Intel[®] StrongARM^{*} SA-1110 Development Board

Specification Update

June 2000

Order Number: **278325-003**

Figure 4-6. Interlaced Frame Buffer

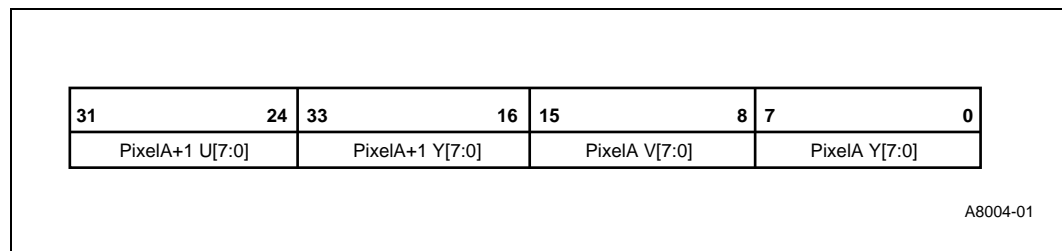
1. Added Video Output Design Section to Chapter 4

Added Video Output Design in Section 4.17. Section 4.17 now appears as follows in the *Intel® StrongARM® SA-1110 Evaluation Board User's Guide*:

The video image in the SA-1110 DRAM must be written in interlaced order and with regard to where the two fields are normally blanked. Although this complicates the rendering code, it is possible to design rendering routines that are just as efficient as normal line sequential rendering. The interlaced frame buffer image in SA-1110 DRAM contains YUV components in 4.2.2 format. Each 32-bit word in the DRAM frame buffer contains four 8-bit video components appearing as UYVY.

Figure 2-3. Li-Ion Battery Location

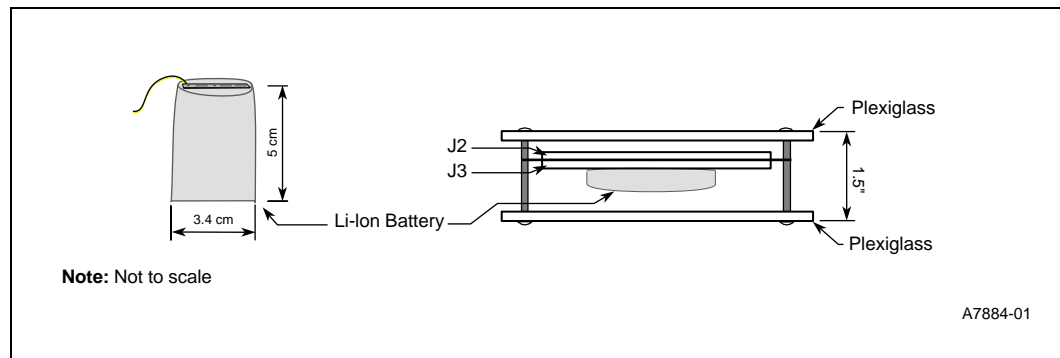
3. Connecting Power from an AC Adapter: Section 2.2.1

This section has been modified, renamed, renumbered and now appears as follows:

1. Verify that the Li-Ion battery is installed on the SA-1110 Development Board and that the battery harness is connected to J4 (see [Figure 2-3](#) for the location of the Li-Ion battery).

Figure 2-6. Li-Ion Battery Location

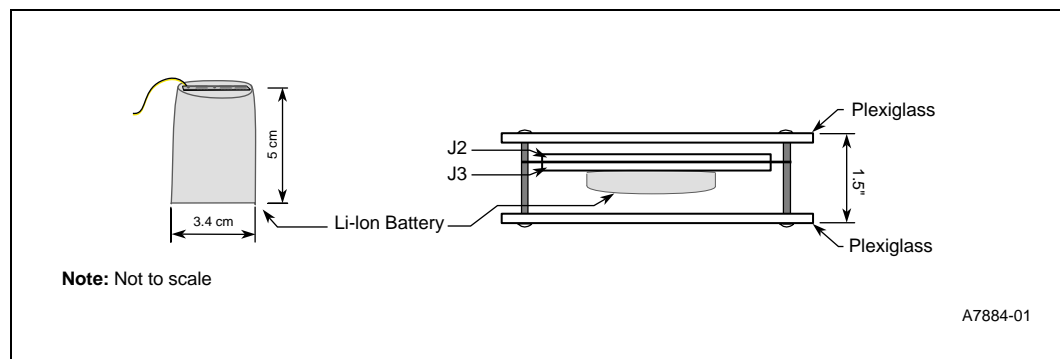
4. Connecting Power from the Li-Ion Battery: Section 2.2.2

This section has been modified, renamed, renumbered and now appears as follows:

1. Disconnect the battery harness from J4 and remove the Li-Ion battery from the SA-1110 Development Board (see [Figure 2-6](#) for the location of the Li-Ion battery).

Figure 4-8. Waking Circuit

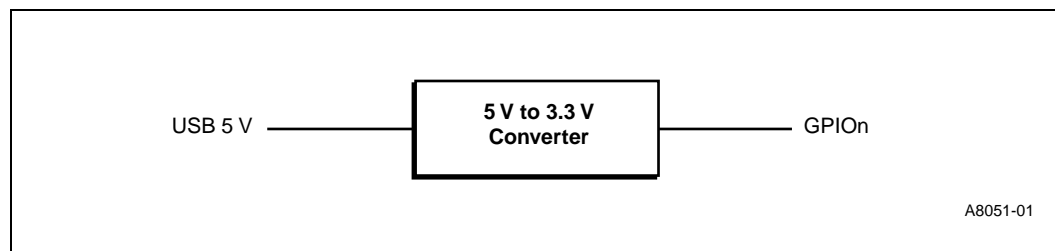
8. USB Client Port: Section 4.18

This section has been updated as follows:

To allow the USB to wake up a sleeping SA-1110 Development Board when it is plugged into a USB host port, the following circuit is required:

The USB port implementation on the SA-1110 Development board attempted to supply up to 500 mA of current at 5 V for use by the SA-1110 Development Board. However, this implementation does not conform to USB specifications for bus powered devices.

The SA-1110 device cannot support a bus powered device model because when the host initiates a suspend, the device is required to consume less than 500 μ A (for more information, see section 7.2.3 of the USB specification, version 1.1). The device cannot limit its current consumption to 500 μ A unless it enters sleep mode. Unfortunately, if the device enters sleep mode, all of the UDC registers are reset, and then it will not respond to its host-assigned address.

To prevent the SA-1110 Development Board from drawing power from the USB host, remove D6.
